METRO BUILDING SUPPLY ADDITION

RE: SUB 2004-74 -- One-Step Final Plat of Metro Building Supply Addition

At the regular meeting of the Subdivision Committee of the Metropolitan Area Planning Commission on Thursday, July 1, 2004, the above captioned plat was considered. The action of the Committee was to approve the one-step final plat, subject to the following staff comments:

CASE NUMBER: SUB 2004-74 -- METRO BUILDING SUPPLY ADDITION

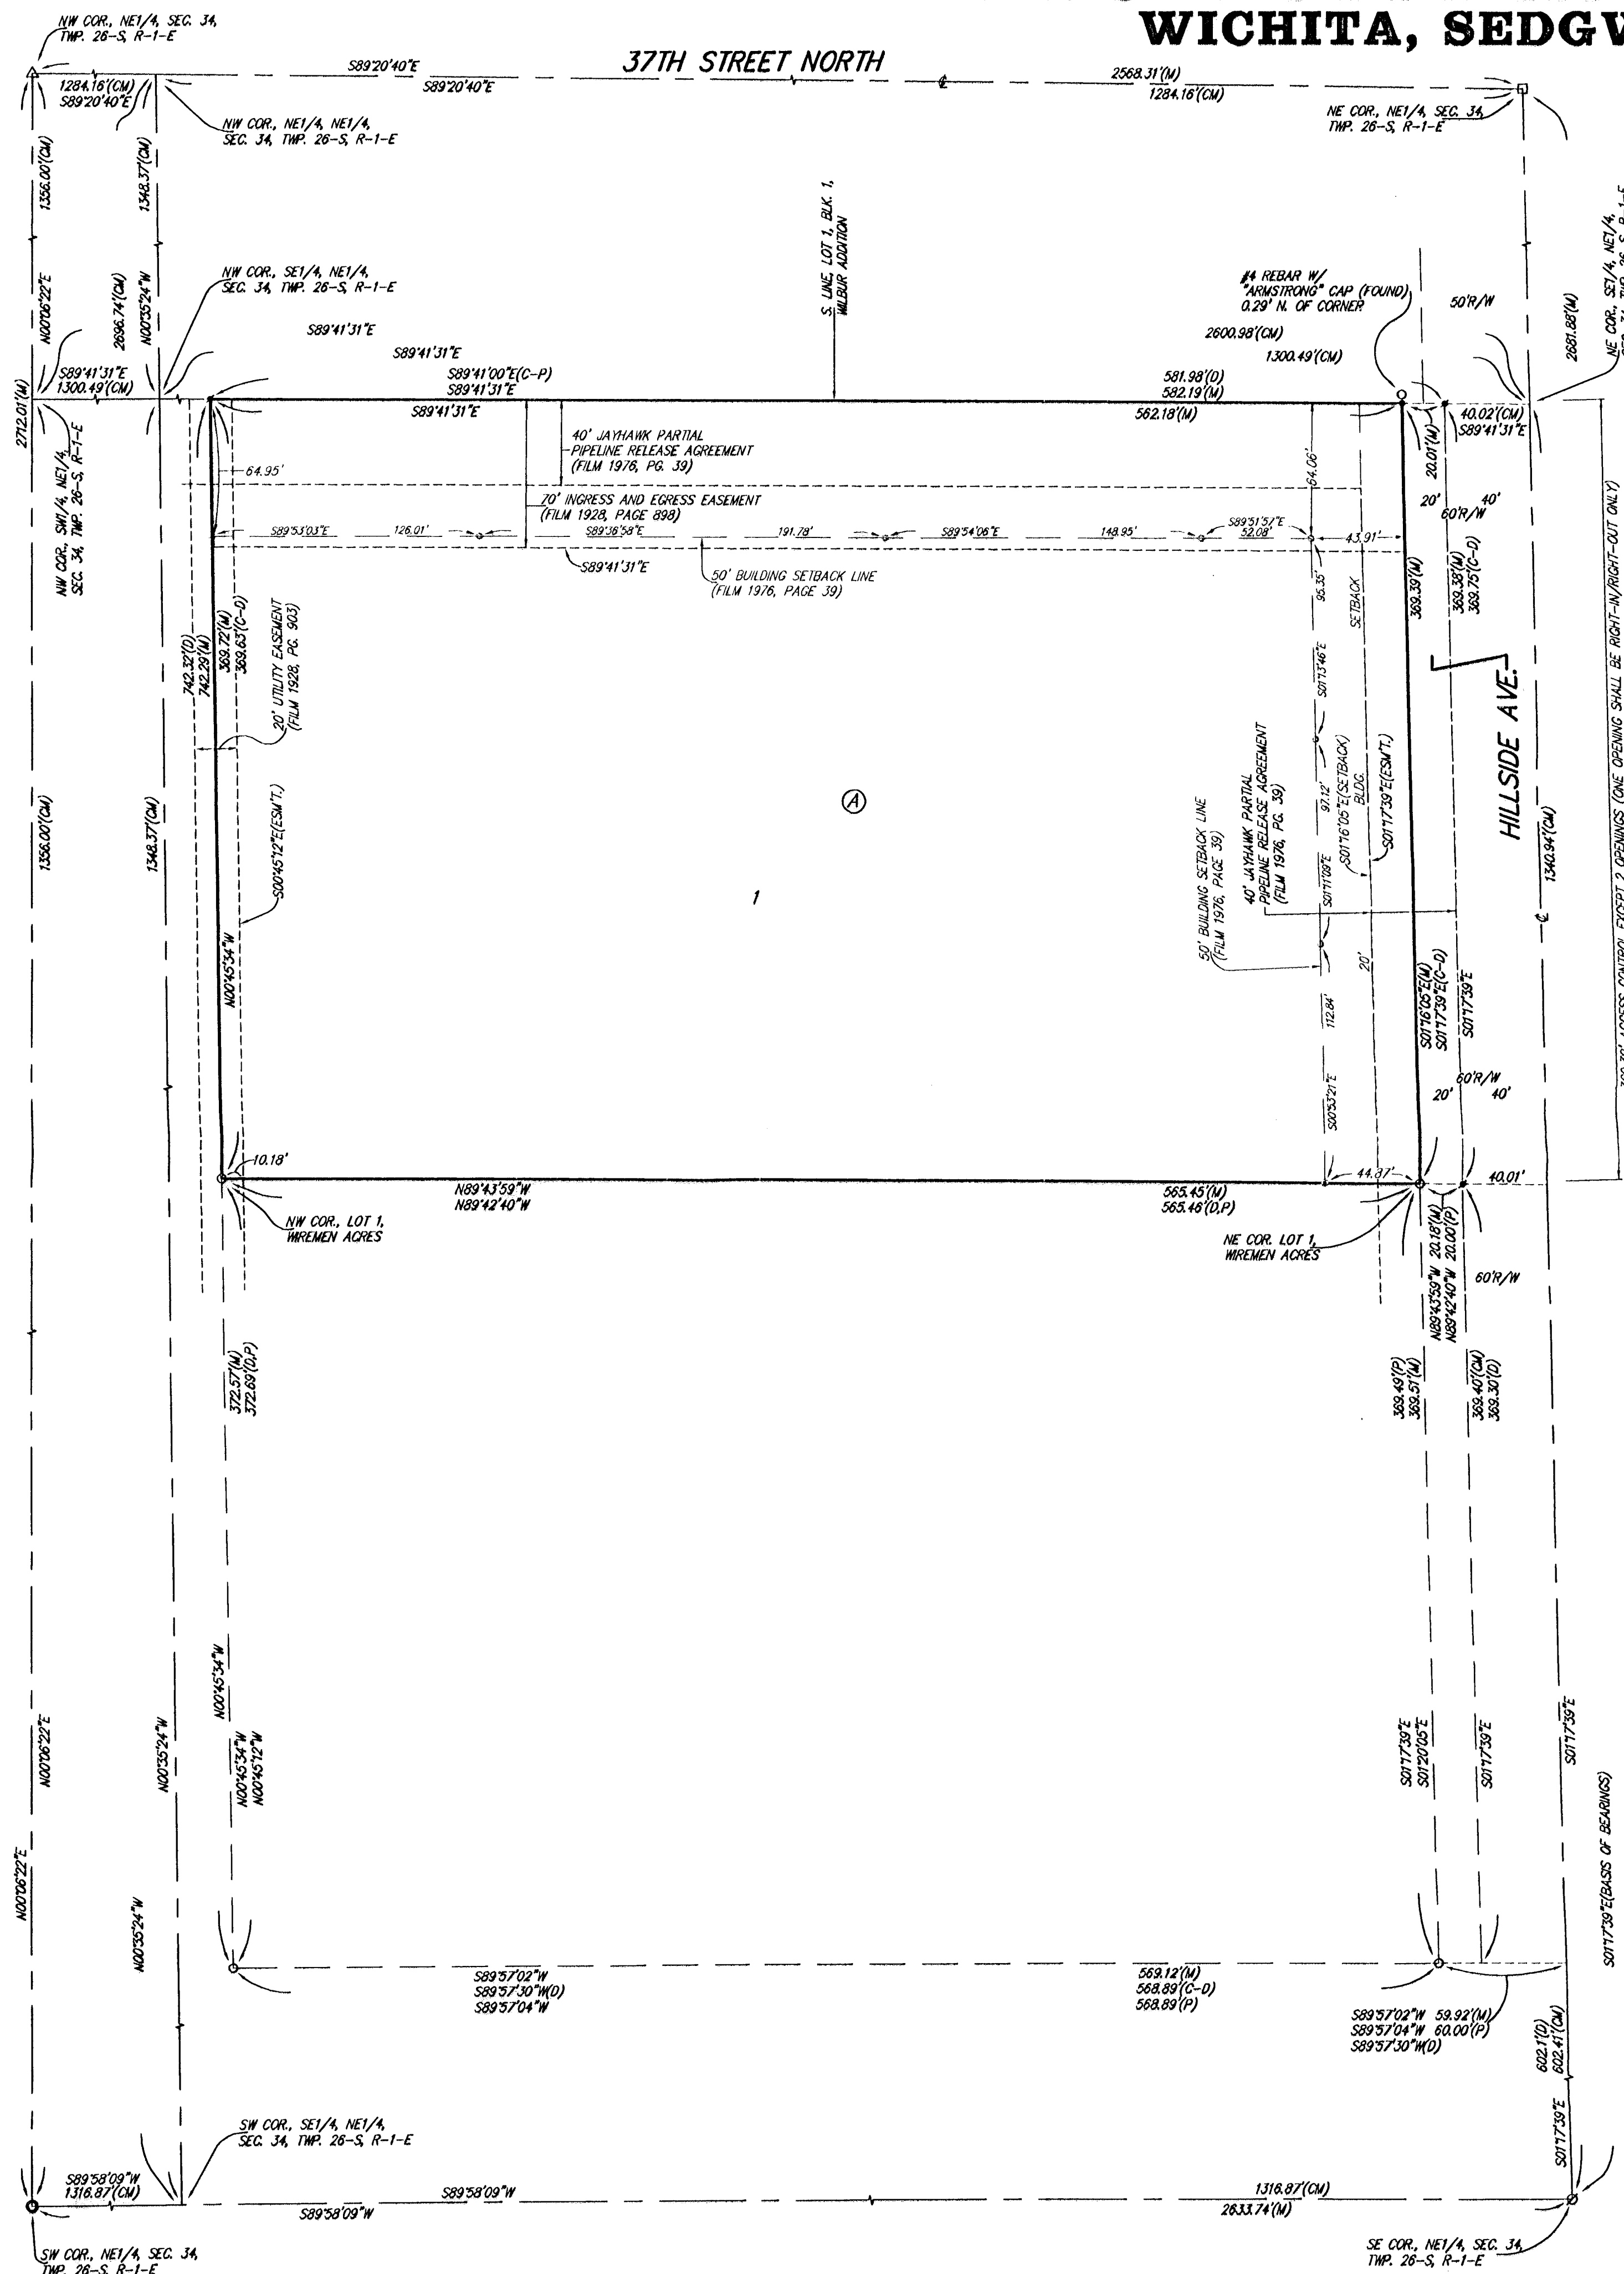
- C. City Engineering needs to comment on the status of the applicant's drainage plan. The drainage plan is approved.
- D. The plat proposes two street openings to Hillside. Traffic Engineering has approved one opening with full turning movements, another opening limited to right turns in-out only. A note shall be placed on the plat regarding access controls being in accordance with the Access Management Regulations.

- G. The applicant shall submit a copy of the instrument which establishes the pipeline easements on the property, which verifies that the easements shown are sufficient and that utilities may be located adjacent to and within the easements. Any relocation, lowering or encasement of the pipeline, required by this development, will not be at the expense of the City.

- H. The applicant's agent shall determine any setback requirements for the pipelines by researching the text of the pipeline agreements. If a setback from the pipeline easements is provided for in the pipeline easement agreements, it shall be indicated on the face of the plat.

- I. The plat's text shall include language that a drainage plan has been developed for the plat and that all drainage easements, rights-of-way, or reserves shall remain at established grades or as modified with the approval of the applicable City or County Engineer, and unobstructed to allow for the conveyance of stormwater.
